MITSUBISHI ELECTRIC Inverter

No. 847E

Appearance Change of the FR-BMF Series Inverter Option to Support Rear Panel Installation for the FR-D840-11K/15K

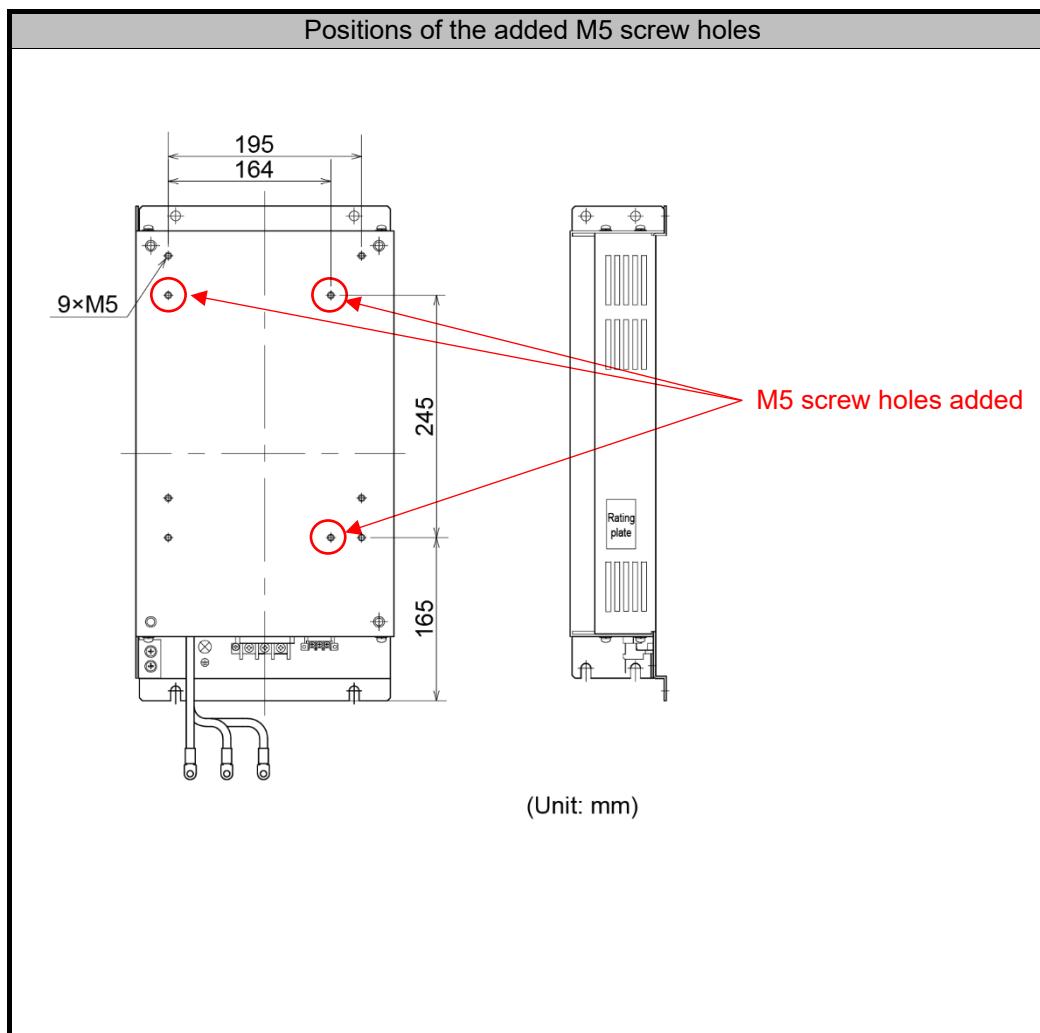
M5 screw holes will be added to support rear panel installation for the FR-D840-11K/15K.
